NOTICE OF VIOLATION

On June 18, 2025, Energy Safety conducted an inspection of Southern California Edison Company's WMP initiatives in the vicinity of the city of Lake Elsinore, California. The inspection report is enclosed herewith. Energy Safety found the following violation:

INSPECTION REPORT

Electrical Corporation:	Southern California Edison Company
Report Number:	CAD_SCE_SIS_20250618_1028
Inspector:	Samuel Isaiah
WMP Year Inspected:	2024
Quarterly Data Report (QDR) Referenced:	Quarter 4 (Q4)
Inspection Selection:	Energy Safety viewed the contents of the Q4 QDR and performed an analysis that resulted in the selection of the WMP initiatives and locations referenced in this report.
Relevant WMP Initiative(s):	8.1.3.1 - Distribution Detailed Inspections and Remediations (IN-1.1)
Date of inspection:	June 18, 2025
City and/or County of Inspection:	Lake Elsinore, Riverside County
Inspection Purpose:	Assess the accuracy of Southern California Edison Company's QDR data, completeness of its work, compliance with WMP requirements, and compliance with its protocols.

Violation 1

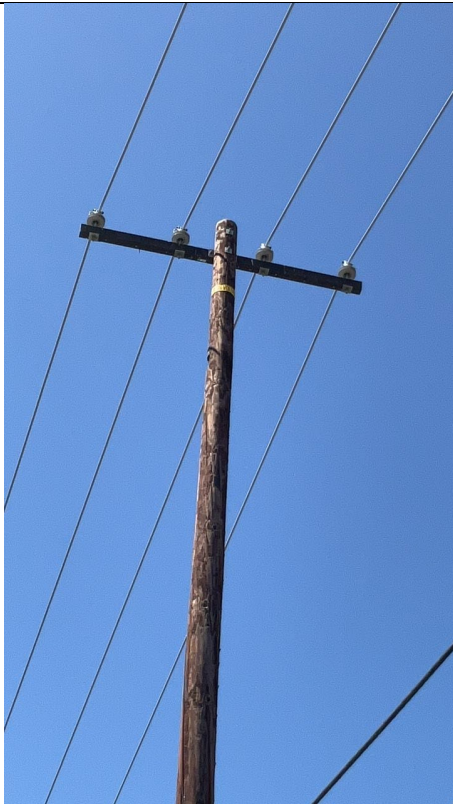
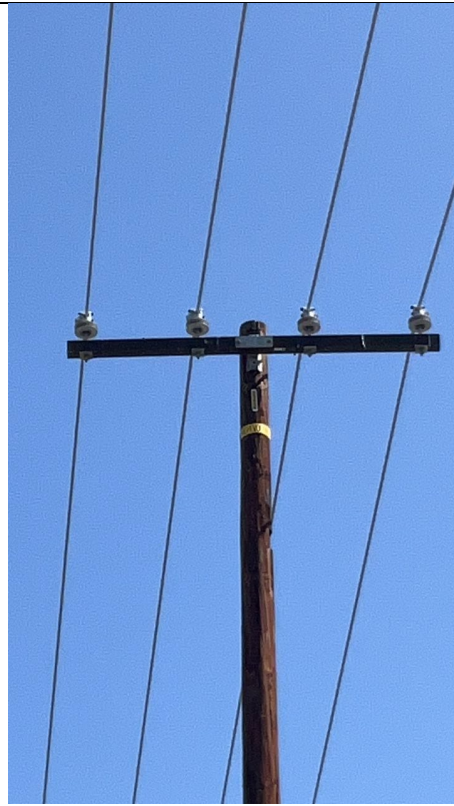
On Pole ID 4234530E, Grid Hardening ID 409911517-4234530E, at 28993-30655 Lake St, Lake Elsinore, CA, 92530, USA, 33.698648, -117.390164, the inspector observed that no wildlife covers were installed. The inspector's observation is documented in Violation 1 photographs, which are attachments to this report. Photo numbers IA1Img1, IA1Img2 and IA1Img3 depict there are no wildlife covers on the pole. Per information provided by SCE to the Compliance Inbox on April 3, 2025, at 12:15 pm, wildlife covers, referred to as avian protection, was installed.

1. Southern California Edison Company's 2024 Q4 QDR for WMP 8.1.3.1 Distribution Detailed Inspections and Remediations work identified that the remediation of wildlife covers was completed at this location.
2. The wildlife covers were not installed.

IA1Img1: View showing no wildlife covers installed

IA1Img2: View showing no wildlife covers installed
